May 19, 2005
LIC-05-0065

SUBJECT: Fort Calhoun Station Unit No. 1, Supplemental Response to Request for Additional Information on the Revised Relaxation Request for First Revised Order (EA-03-009) Establishing Interim Inspection Requirements for Reactor Pressure Vessel Heads at Pressurized Water Reactors

**Supplemental Response to Request for Additional Information on the Revised
Relaxation Request for First Revised Order (EA-03-009) Establishing Interim
Inspection Requirements for Reactor Pressure Vessel Heads at Pressurized
Water Reactors**

Attachment 1, Figure 1

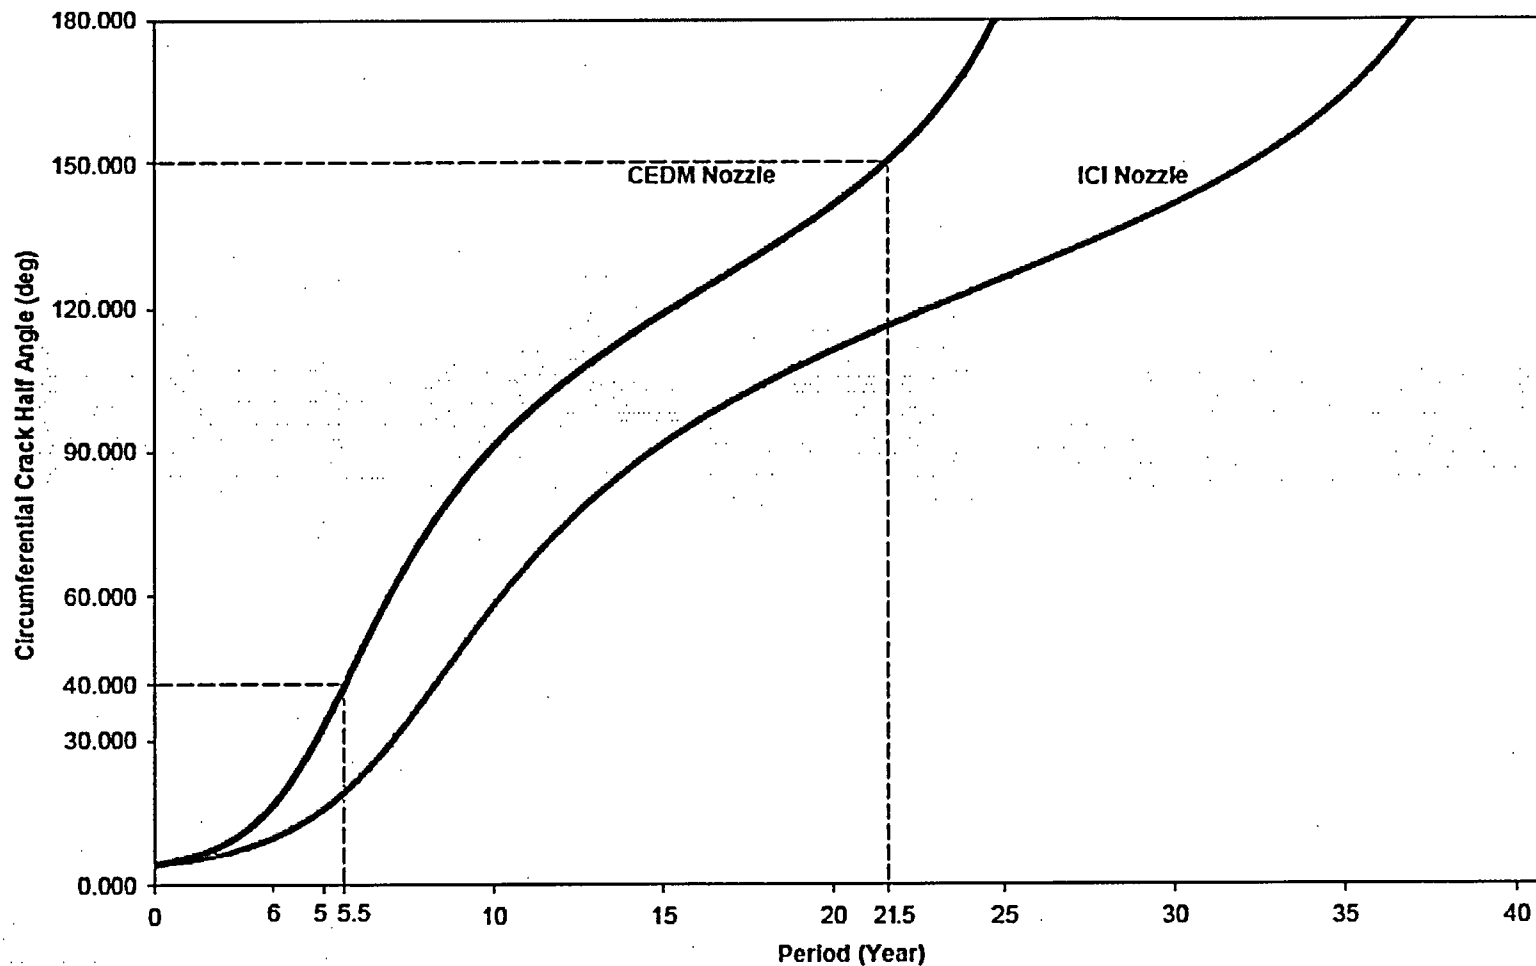
NRC Question 1:

With regards to the Control Element Drive Mechanism (CEDM) Nozzle No. 25 relaxation request, assume a through-wall circumferential flaw in an 80 degree circumference (worst case scenario) is present in the uninspected area. Please provide discussion to confirm that it will take more than one operating cycle for a through-wall flaw of 80 degrees in circumference to propagate to 300 degrees, assuming 300 degree is the critical size. Also, please confirm that that Reference 8 [CEOG Report #CEN-614, "Safety Evaluation of the Potential for and Consequences of Reactor Vessel Head Penetration Alloy 600 OD Initiated Nozzle Cracking," December 1993] of Attachment 2 of Reference 2 is still applicable for Nozzle No. 25.

EPRI Report MRP-104 (Reference 1) discusses the time for a flaw to grow through-wall, and then the time for a circumferential flaw to reach critical flaw length. Figure 1 (excerpted from Reference 1) shows the time in Combustion Engineering Plants for circumferential flaws to grow to various sizes in CEDM and In-Core Instrumentation (ICI) nozzles. OPPD has added lines to this figure to show the areas of interest as discussed below.

Applying the conditions seen in CEDM nozzle 25 at Fort Calhoun Station Unit No. 1 (FCS), the time to grow from 40.000 degrees (equivalent to 80 degrees in nozzle 25) to a conservative critical flaw length of 150.000 degrees (equivalent to 300 degrees in nozzle 25) is approximately 16 years. This is well in excess of one operating cycle. The 16 years is conservative on both ends. The hypothetical flaw is not through-wall at FCS, because the bare metal visual examination found no boric acid deposits. Also, 300 degrees is conservative, because it is less than the 330 - 350 degrees required for CE Plants to reach critical flaw length.

CEOG Report # CEN-614, "Safety Evaluation of the Potential for and Consequences of Reactor Vessel Head Penetration Alloy 600 OD Initiated Nozzle Cracking," December 1993 remains applicable for CEDM penetration nozzle 25 at FCS. Reference 1 is a more recent report that contains similar conclusions.
